RE: Don Pedro Project (FERC Project No. 2299); Response of Turlock and Modesto Irrigation Districts to the Federal Energy Regulatory Commission's July 16, 2009 Order (128 FERC ¶ 61,035) Regarding Instream Flow and Water Temperature Model Study Plans

Lower Tuolumne River Instream Flow Studies Final Study Plan

Lower Tuolumne River Water Temperature Modeling Final Study Plan

Subject: Don Pedro Hydroelectric Project, FERC # 2299, Tuolumne River,
California – Service Comments on Instream Flow and Water
Temperature Study Plans

Figure 2. Conceptual example of transect weighting method for reach extrapolations proposed for the lower Tuolumne River IFIM study.

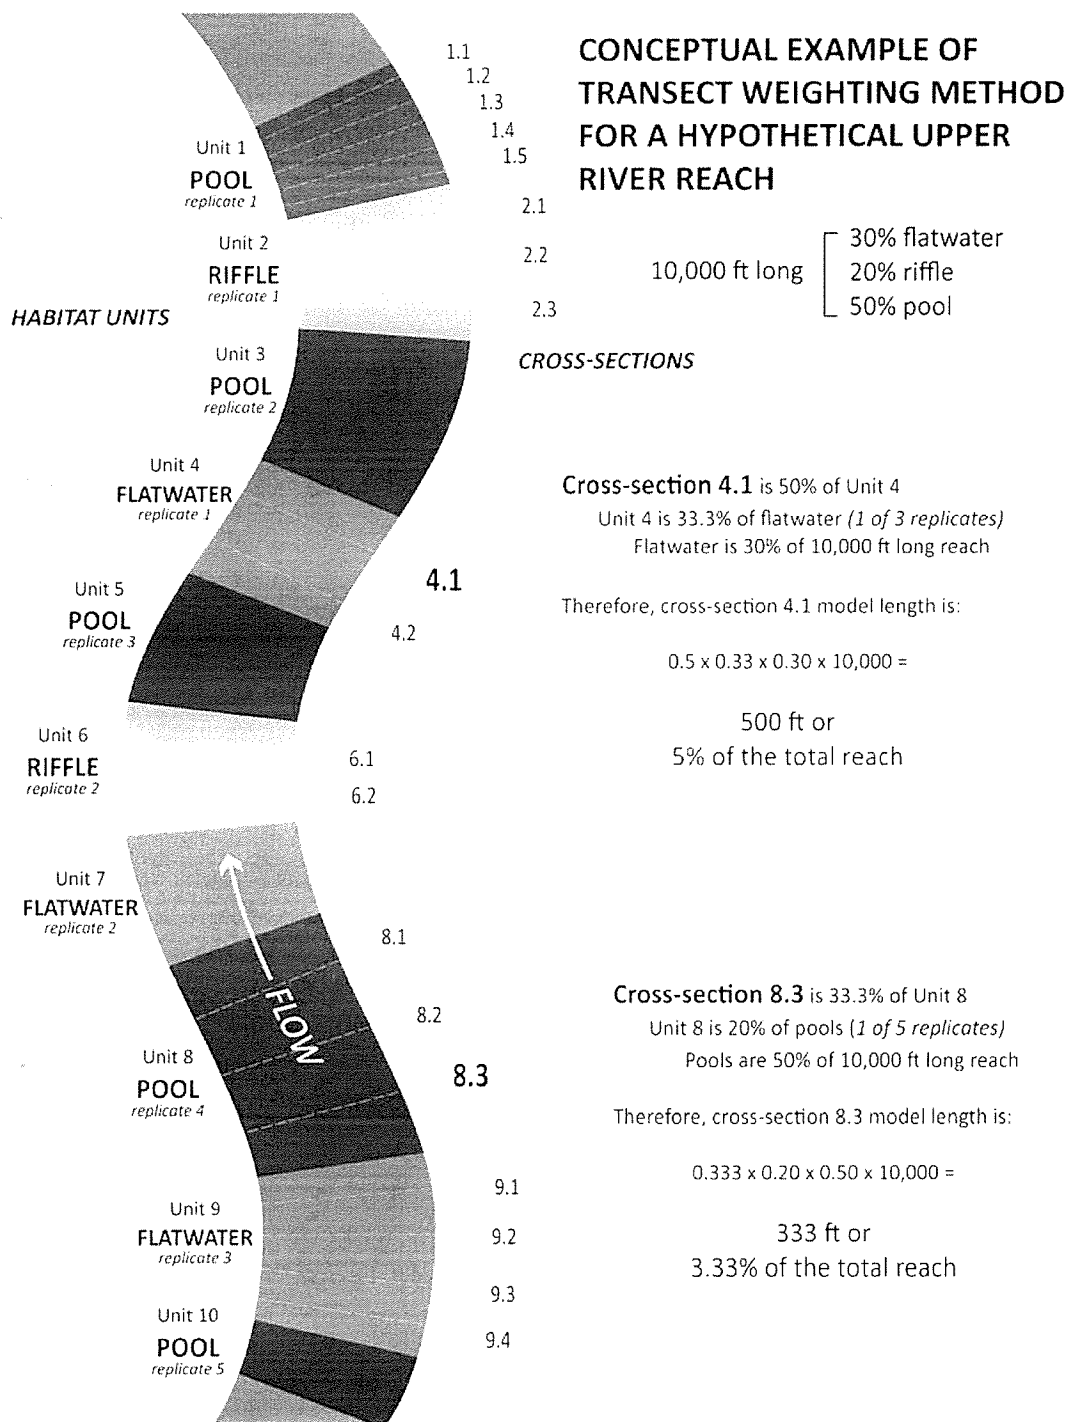
In section 3.4.6, Habitat Modeling, and in Figure 2, the Districts suggest that cross sections in the same mesohabitat unit be weighted based on the number of cross sections in the unit. The Department recommends that all cross sections in similar mesohabitat unit types within a study reach be given equal weight.
